**Addendum No. 3**

**Final Environmental Impact Report  
for Metro Gold Line Foothill Extension - Azusa  
to Montclair (SCH 2010121069)**

**Evaluating Minor Design Changes of the Project  
Azusa to Montclair**

Metro Gold Line Foothill Extension Construction Authority  
March 2016

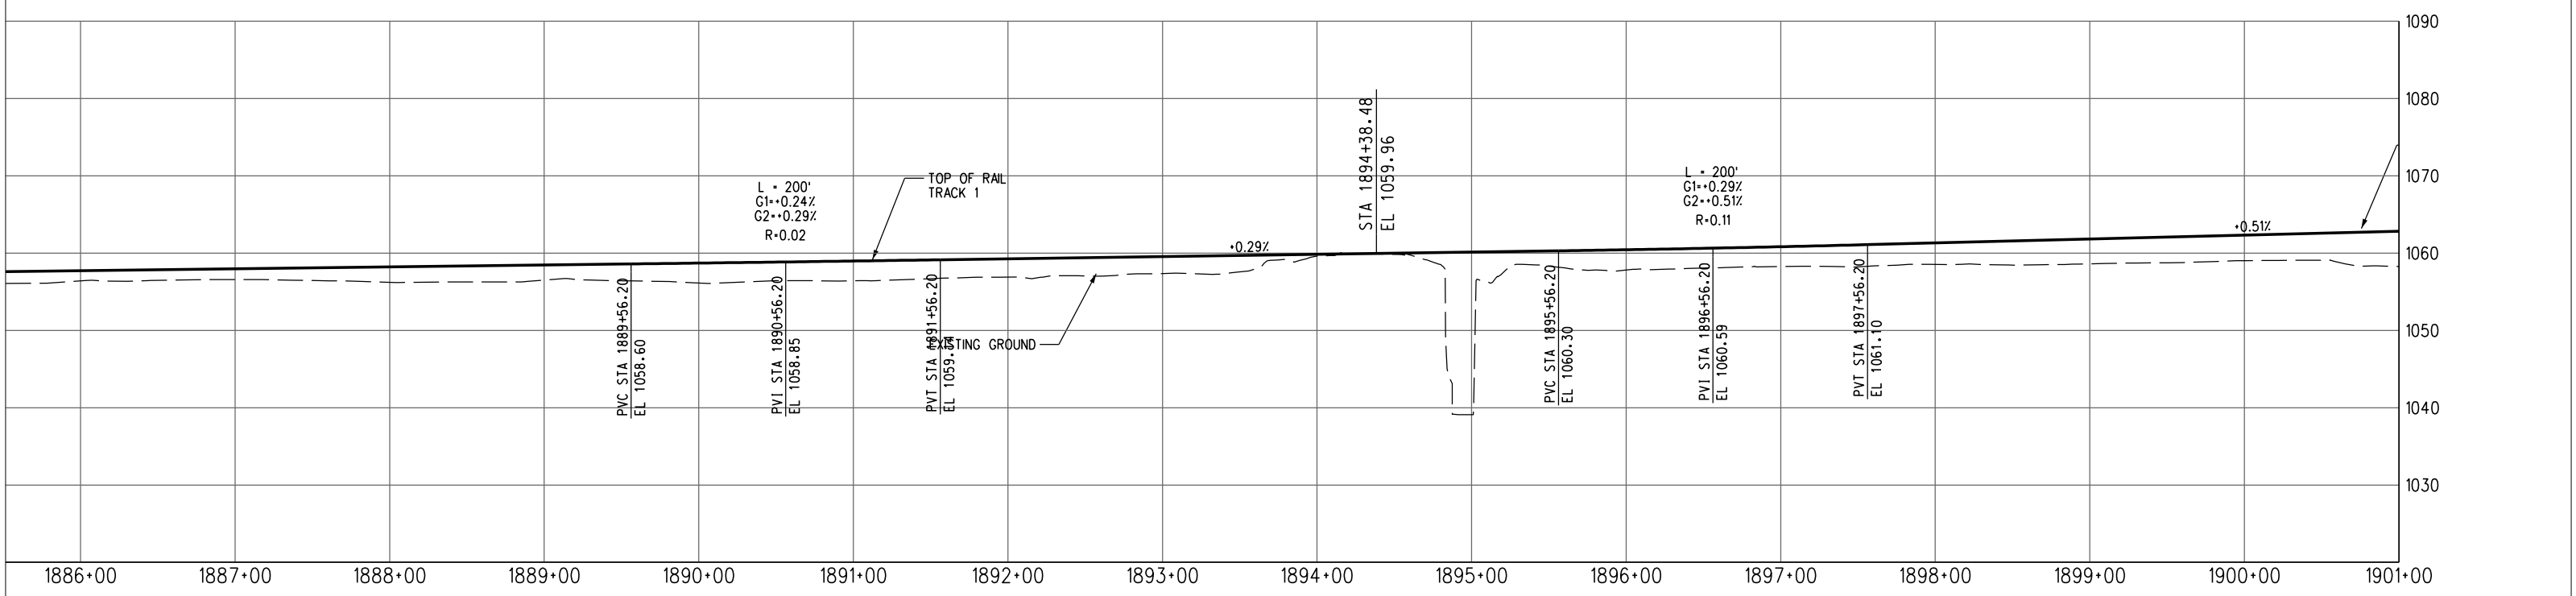
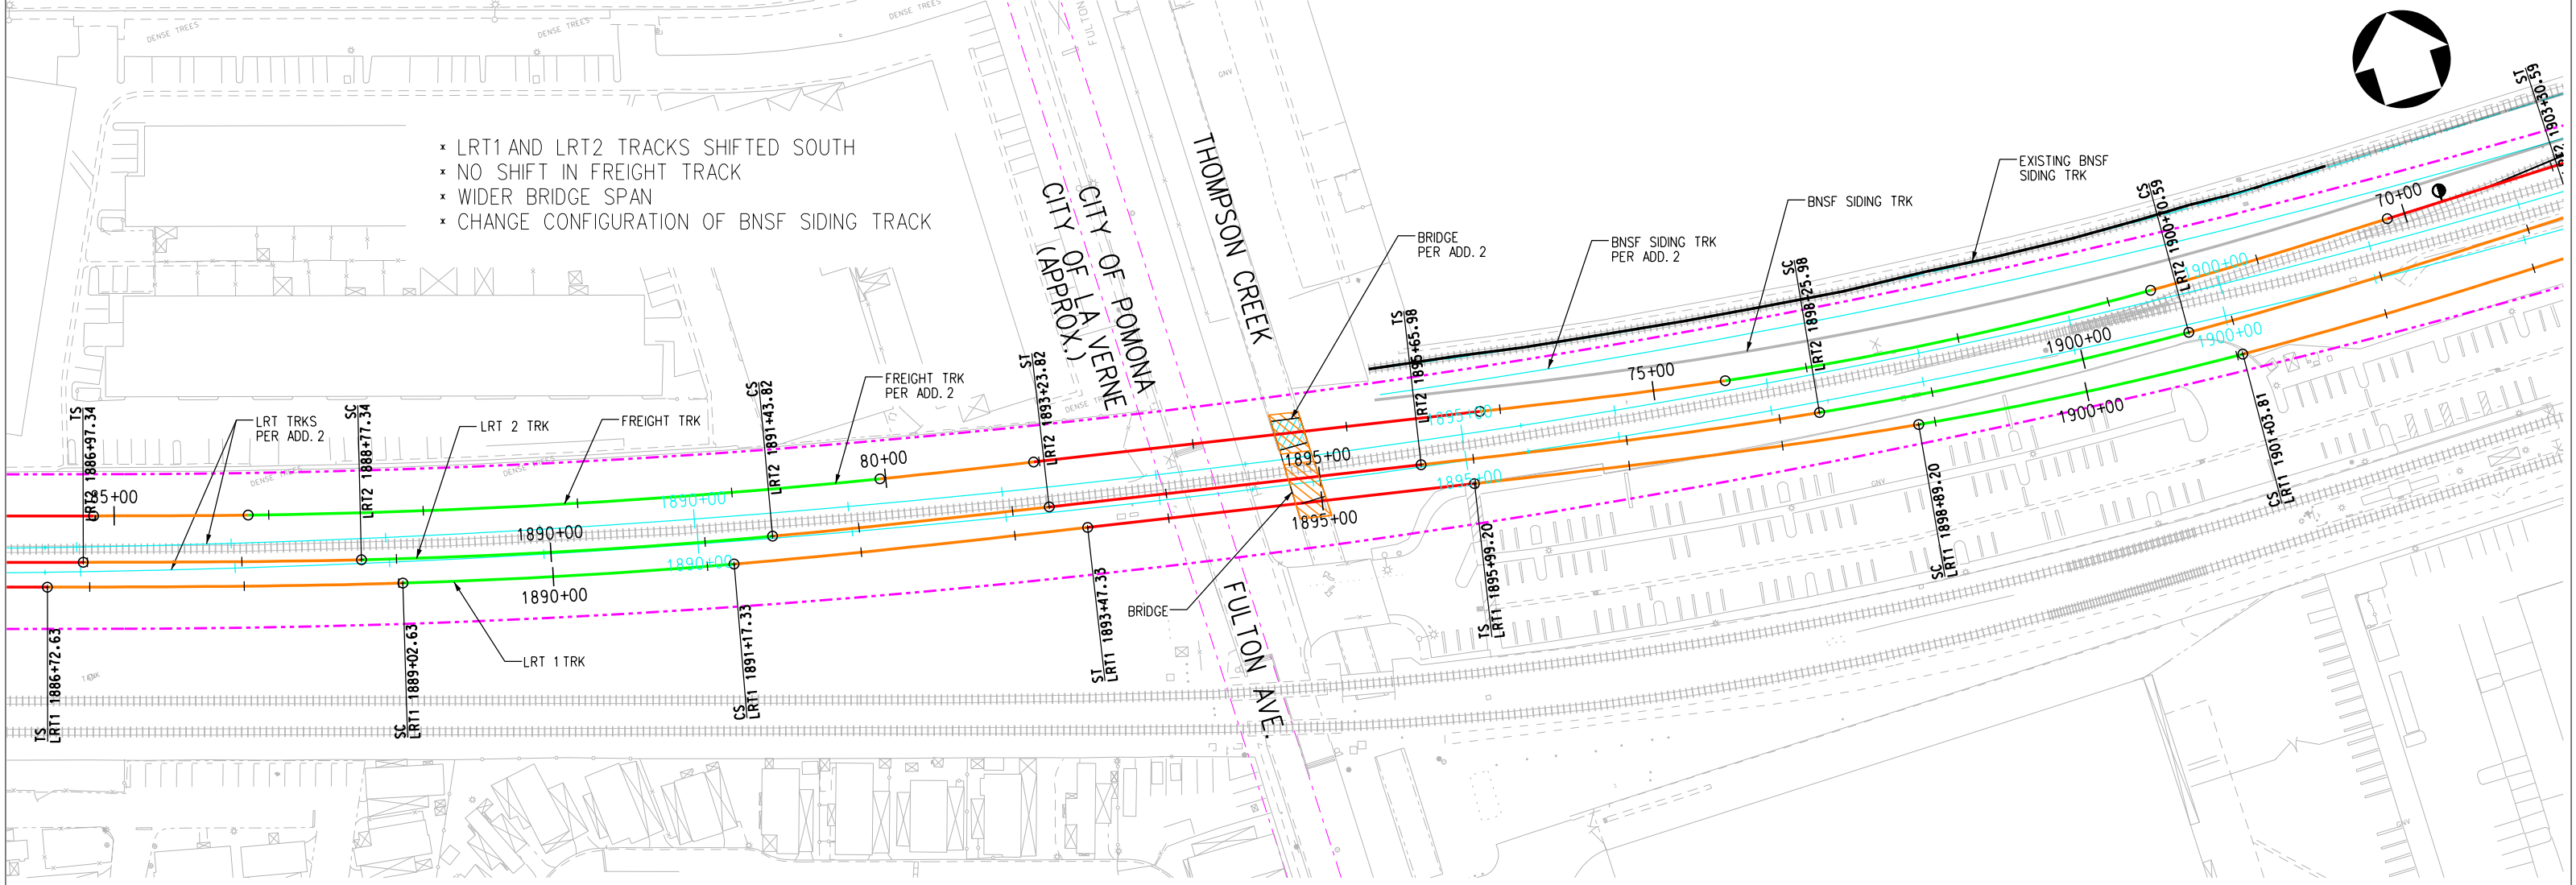
- \* LRT1 AND LRT2 TRACKS SHIFTED SOUTH
- \* NO SHIFT IN FREIGHT TRACK
- \* WIDER BRIDGE SPAN
- \* CHANGE CONFIGURATION OF BNSF SIDING TRACK

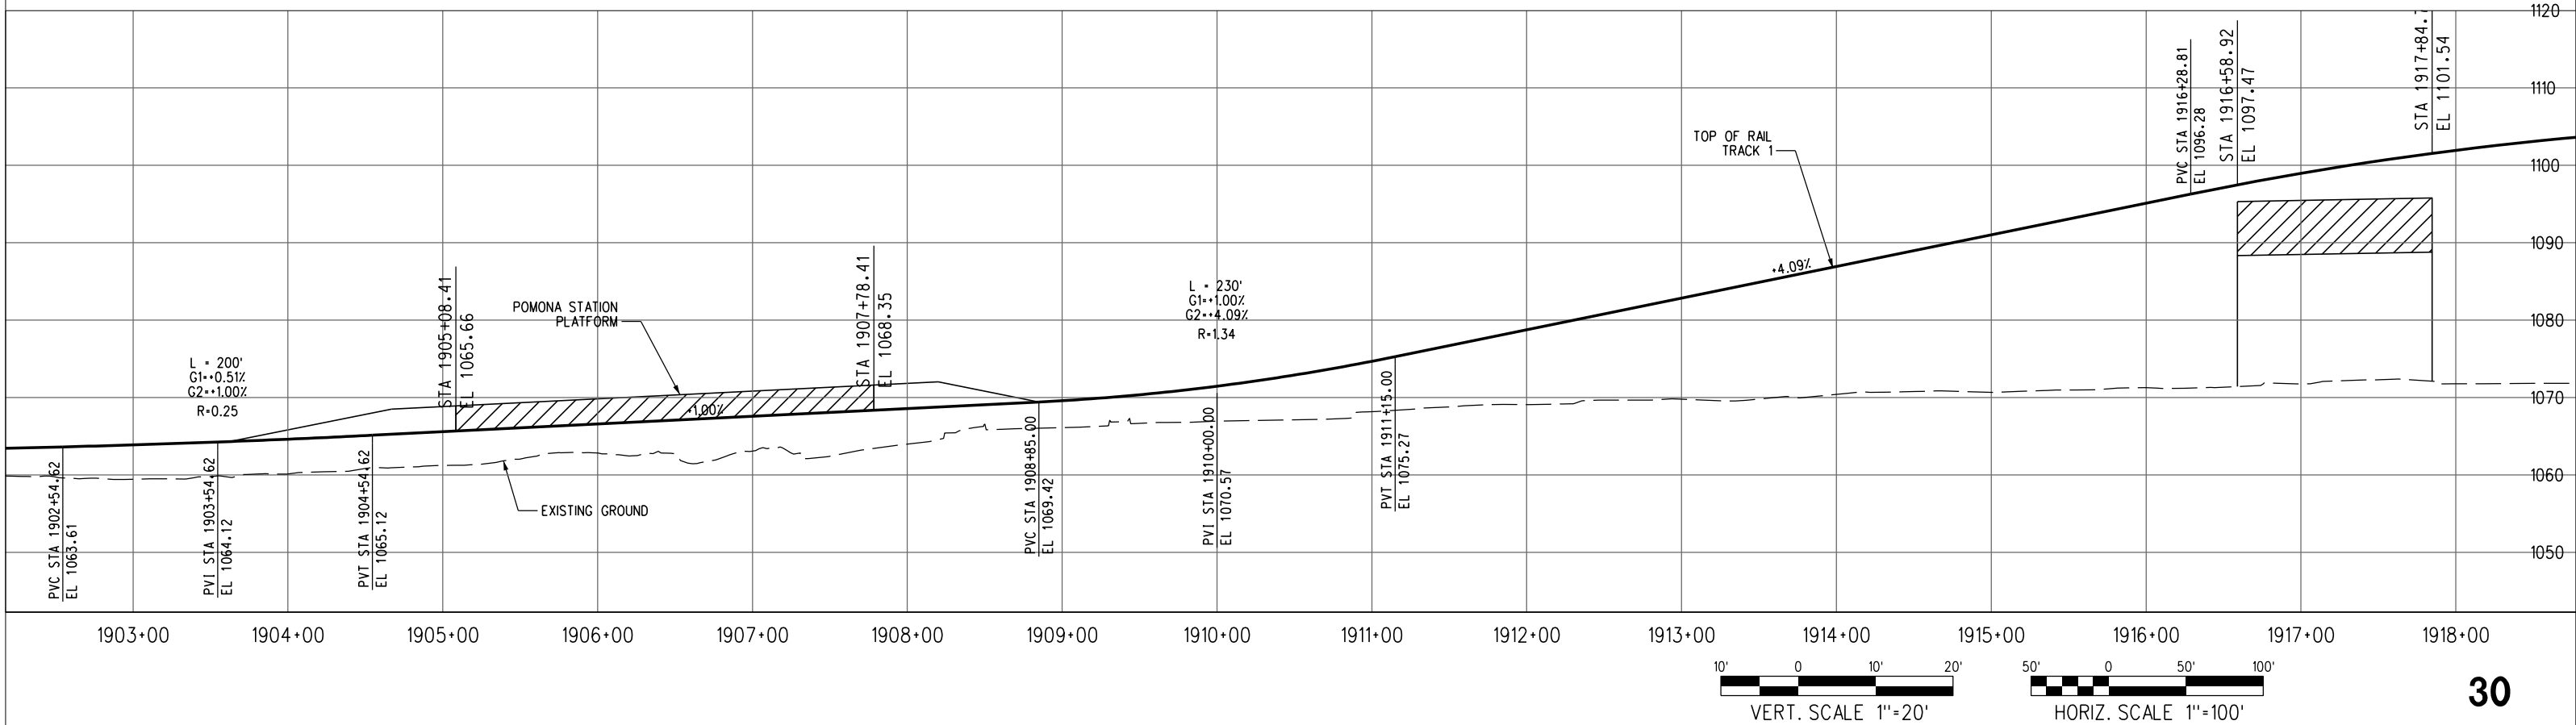
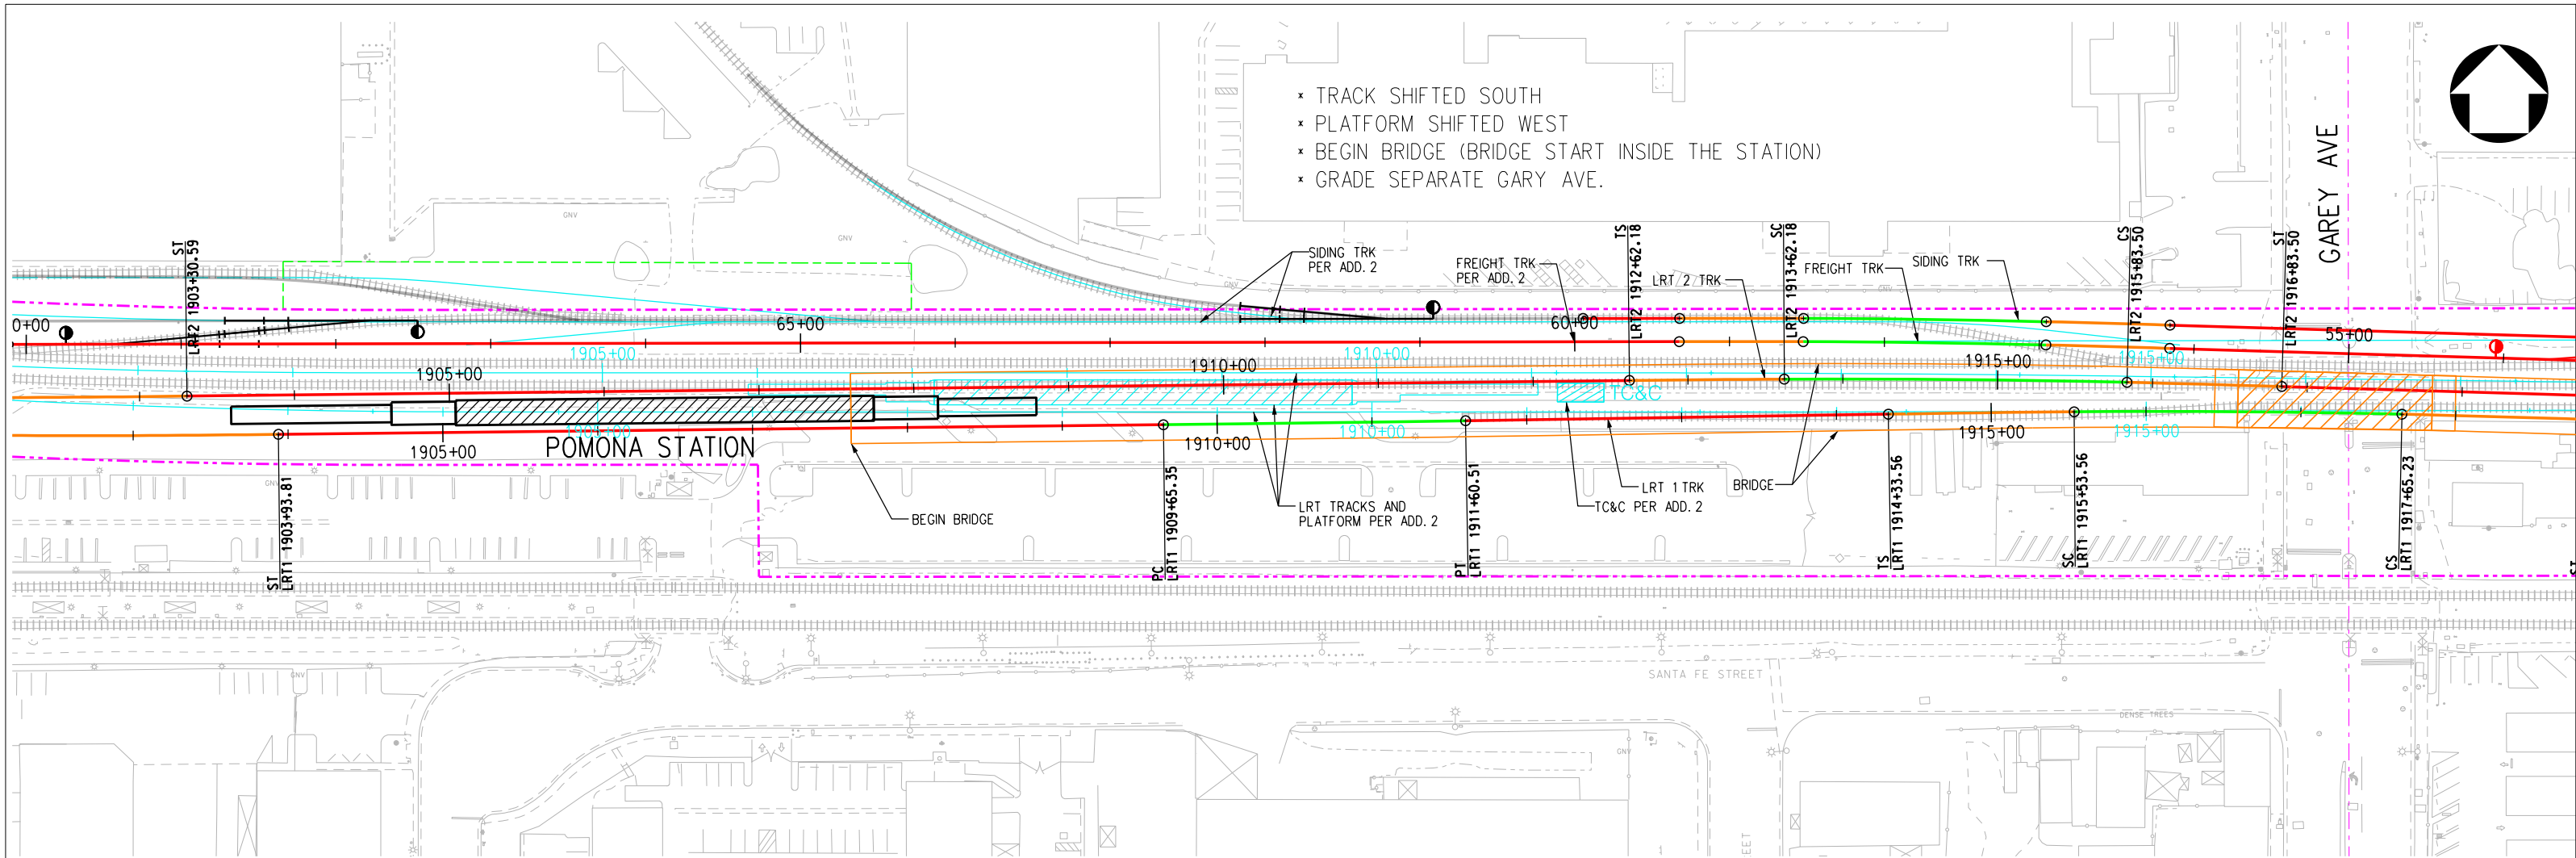
- × TRACK SHIFTED SOUTH
- × PLATFORM SHIFTED WEST
- × BEGIN BRIDGE (BRIDGE START INSIDE THE STATION)
- × GRADE SEPARATE GARY AVE.
